April 13, 2010

Charlie Hoppin, Chair and Board Members  
State Water Resources Control Board  
1001 I Street  
Sacramento, CA 95814  
*Via electronic mail:* [commentletters@waterboards.ca.gov](mailto:commentletters@waterboards.ca.gov)

**Re: Comments on Draft Final Substitute Environmental Document and Statewide Water Quality Control Policy on the Use of Coastal and Estuarine Waters for Power Plant Cooling (March 22, 2010)**

Figure 1. Retrofit Cooling Tower Options for California Nuclear Power Plants

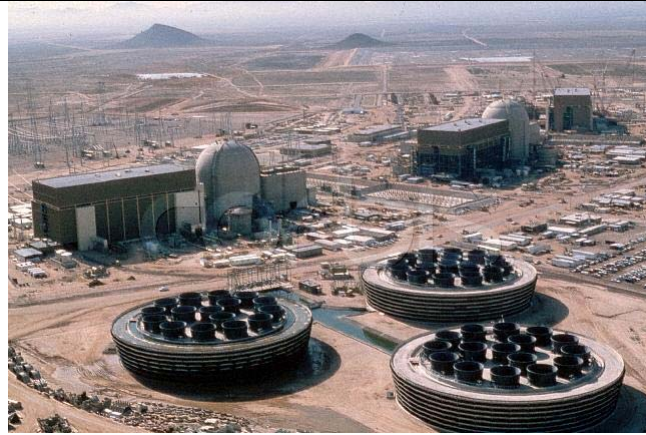
**Not necessarily.** Wet towers can be equipped with plume abatement technology to minimize or eliminate vapor plumes. This is now standard practice in California for power plant cooling towers in urban areas. See Figures 1 and 2.
